4. Issues in the Williams River Catchment Upstream of Seaham Weir

This section of the submissions report responds to issues relating to the Williams River catchment upstream of Seaham Weir while the environmental issues downstream of the weir are addressed in Section 6.

Figure 4.1 Historic and preferred release flows at Glen Martin

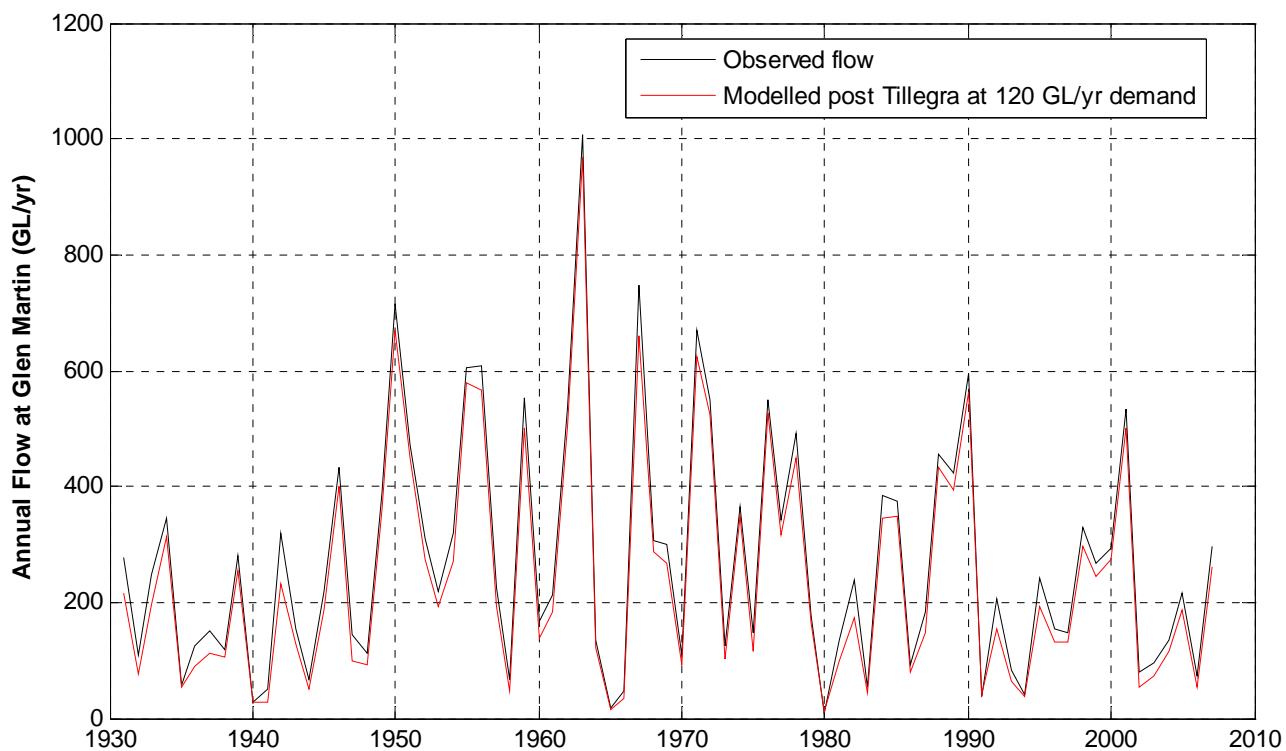
Submissions were concerned that insufficient consideration was given to the *Hunter Unregulated and Alluvial Water Sources Water Sharing Plan* (HUAWSP) and to a 'whole of catchment' approach in the development of the preferred environmental release strategy. A submission noted the EA provides no indication on how water would be removed under the water sharing plan.

During standard operation of Tillegra Dam the preferred release flows would closely mimic the historic flows at Glen Martin. The annual flows at Glen Martin over 77 years of data (1931 to 2007) for the historic and preferred release strategy are illustrated in Figure 4.1 and the daily percentile exceedance for the historic and the preferred release flows at Glen Martin are shown in Table 4.2.
